RECEIPT DATE: 3/6/2020 **ONSITE SEWAGE DISPOSAL SYSTEM** P 567336B

APPROVAL DATE: 4/7/2020 (S7) **PERMIT: CONSTRUCTION** A _____

PROPERTY ADDRESS: 3655 Paupers Folly Lane

SUBDIVISION: Belvedere Estates LOT: 11 TAX ID: _____

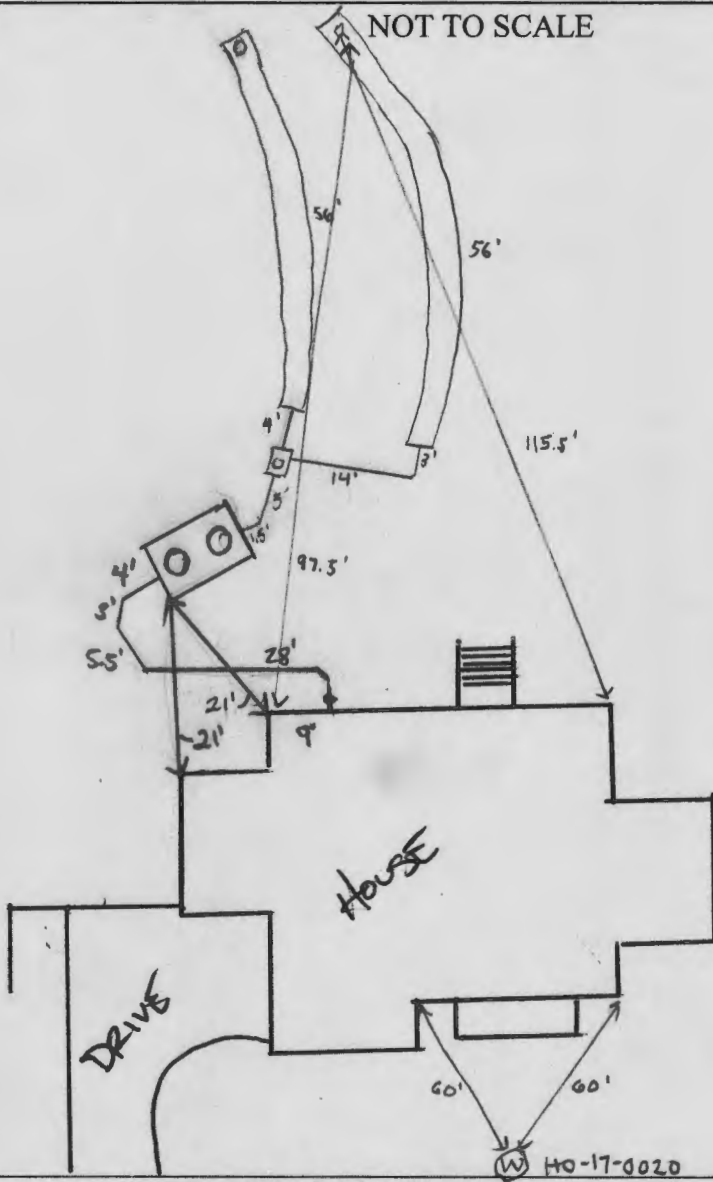
4/1/2020 Trenches staked on contour by surveyor. Third trench staked by accident. First trench is 58', second 67'. Contractor will move trenches up during construction. Hung sewer marked to come out below deck. Drew already placed pipe (8T)

INSTALLATION: 04/06/2020 TANK AND SEWER LINE INSTALLED. BUILDER PUT A DECK OVER THE SEWER LINE AND THE INVERT IS DEEPER THAN PLAN. SHC CONFIRMED W/TAR. CONTACT BUILDER + ENG. (8)

4/7/2020 D-box set and trenches constructed. Trench inlet moved down to 3.5'. (8T)
